Appn No. : 10/002,763

**RESPONSE TO OFFICE ACTION OF 11/16/04  
REMARKS AND ARGUMENTS**

FIG. 1

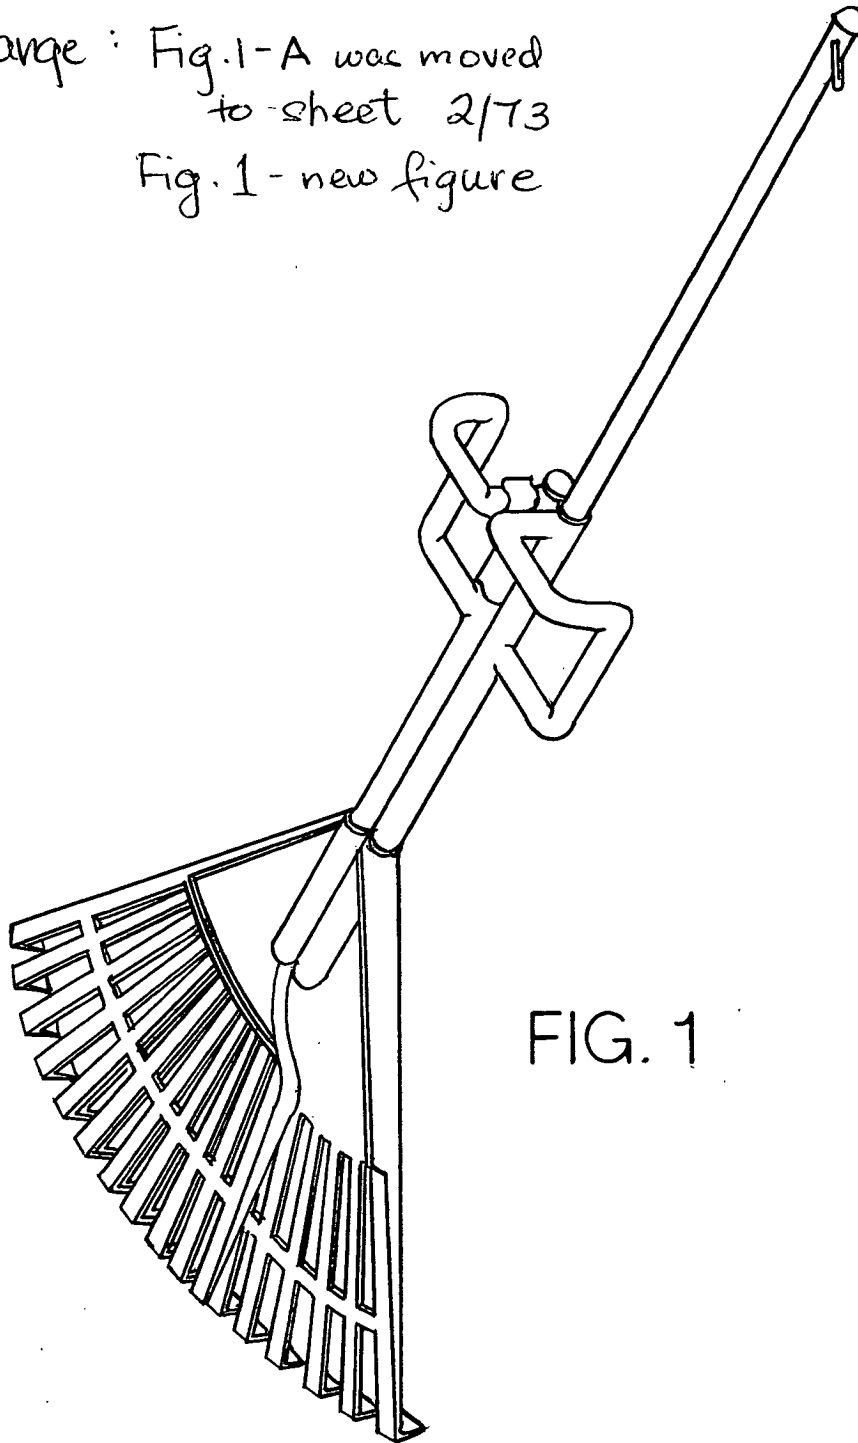
change : Fig. 1-A was moved  
to sheet 2/73  
Fig. 1 - new figure

Fig.1 depicting the elected embodiment is provided as sheet #1. This figure will precede Fig. 1-A in the order of presentation. Since Figs. 1-A and 1-A' are made to fit in one sheet(sheet#2) instead of two, the total number of sheets is maintained. This will minimize the need to re-number the rest of the drawing sheets. The Description of Drawings section of the application has been amended accordingly.

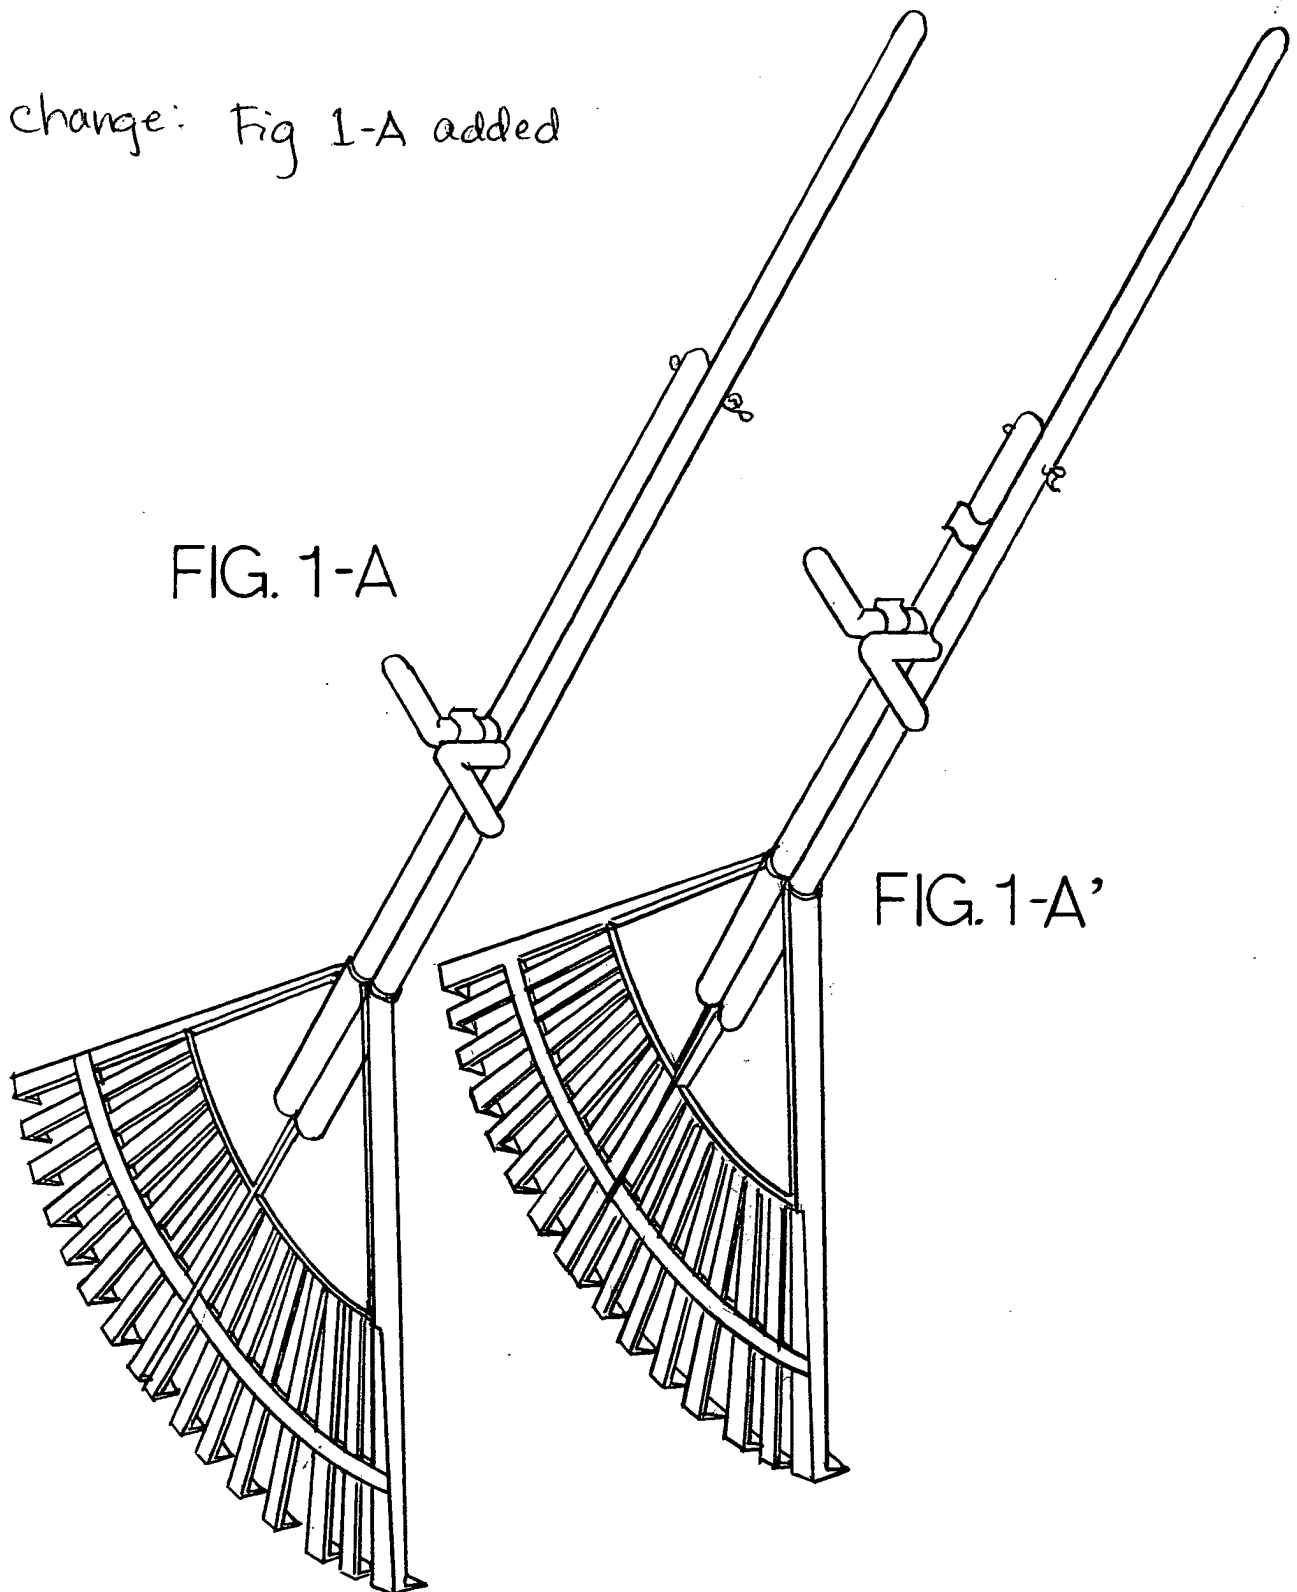
change: Fig 1-A added

FIG. 1-B

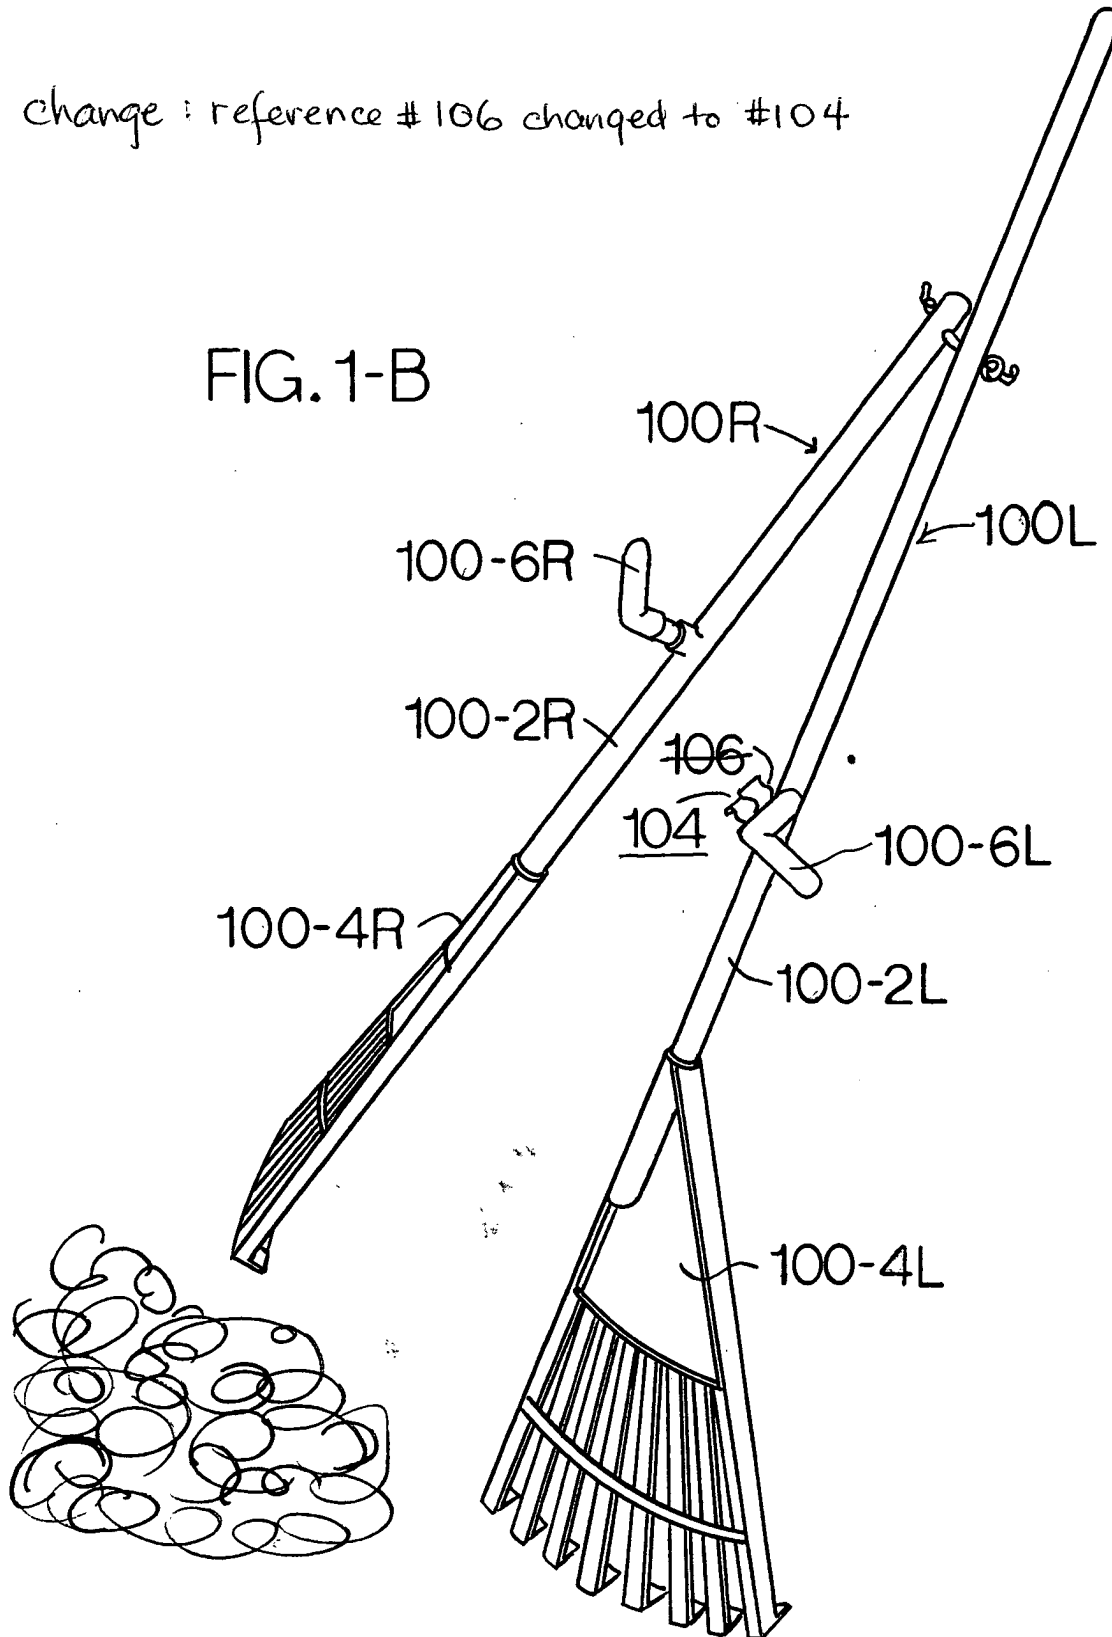
change : reference # 106 changed to #104

In addition, the applicant finds it appropriate to amend Fig. 1-B (sheet#3) and Fig. 1-C (Sheet#4). The reference number for the gripper on the vertical portion of the transverse branch will be changed from #106 to #104. This change is done in order to establish consistency between Fig. 1-B and Fig. 6-CL. In Fig. 6-CL the gripper on the vertical portion of the transverse branch is ref. #104 while the gripper on the elongated member proximal the branches is ref. #106. It is hoped that the resulting consistency will better help the reader see the connection between the embodiment in Fig. 1-A and that in Fig. 6-A, how the former could easily "metamorphose" into the latter. Corresponding amendments to the specification section is also submitted in the Specification Amendments section of this Response. No new material is added.

20/73<sup>+</sup>

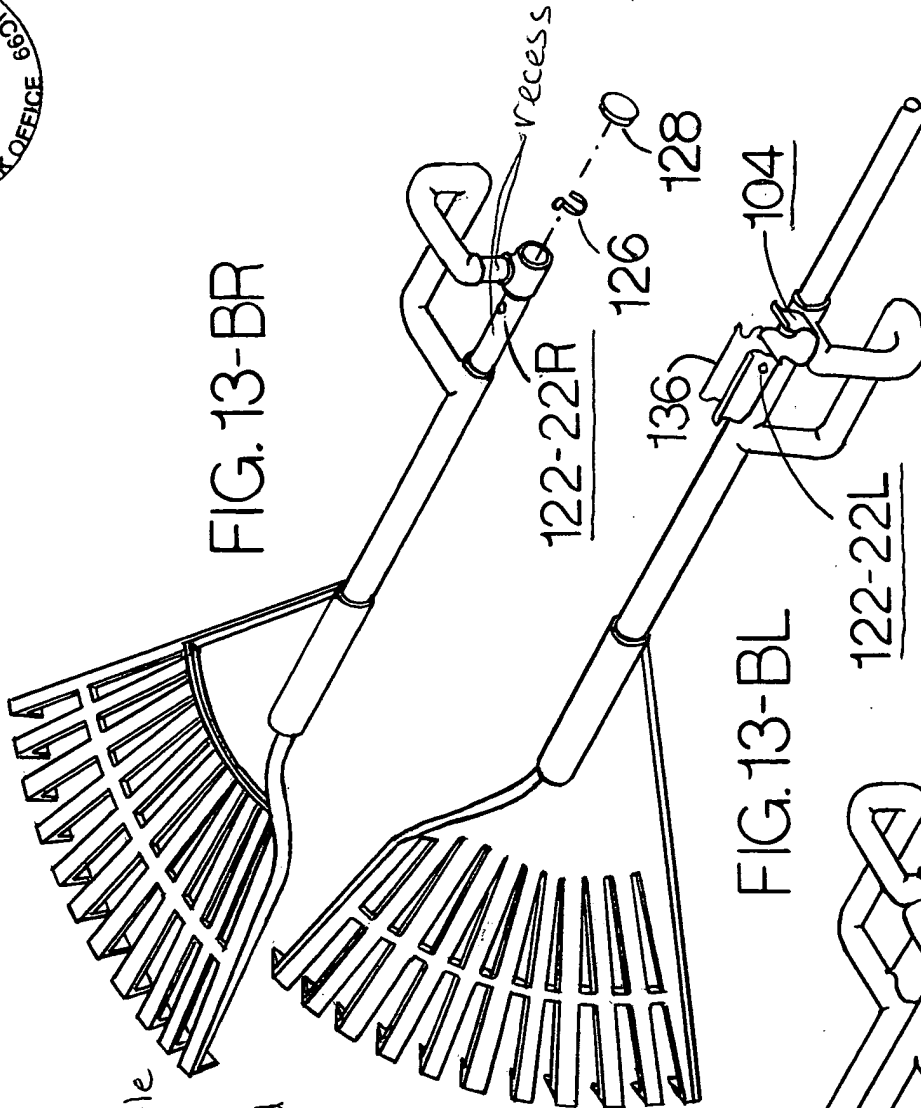
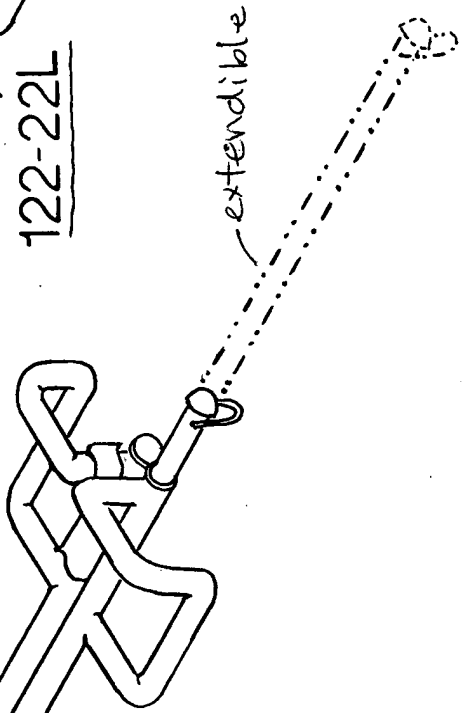
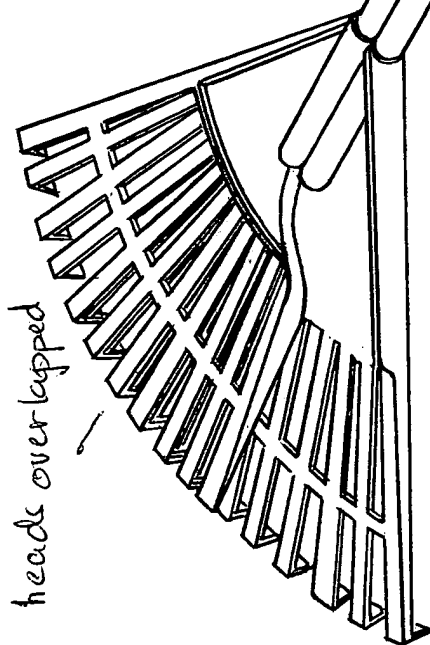
**1. Drawing Objections:** The drawings are objected to under 37 CFR 1.83(a) because the drawings of the specie of Figs.13-A, 13-BL, and 13-BR do not show every feature of the invention specified in the claims, specifically the following:

"abutment means" for claims 89-91

"first and second apertures and snap button" for claim 93

"telescoping tubes" for claim 94

**Figs.13-A, 13-BL, and 13-BR (sheet # 20) are amended to better illustrate the claimed embodiment of the present invention.** No new matter is added. All of elements (a) to (e) above are amply discussed in the specifications and illustrated in the drawings (although not all of them are together in one figure).

Nevertheless, the applicant is trying very hard to comply with the Examiner's requirements if only to have some dependent claims treated on their merit and consequently allowed. The rake heads are overlapped, a second gripper is added, the recessed section is emphasized, the handle is shown as extendible, and the perspective views are revised to show the second aperture. No new matter is added.

The revised perspective views in Figs.13-BL and 13-BR now show the first and second apertures and snap button. No new matter is added.

Fig. 1 and revised Figs.13-A, 13-BL, and 13-BR now show the left rake handle as being extendible. No new matter is added. The details of the extendible handle are discussed under subsection headings Adjustable Handle Length, Version II and More detailed Discussion of Some Means of Telescoping Tubes. These are further supported in Figs.36-A through 43-C.

- change perspective view
- rake heads overlapped
  - handle shown as extendible
  - apertures 122-22L and 122-22R are shown
  - recesses are emphasized
  - 2nd gripper 104 added
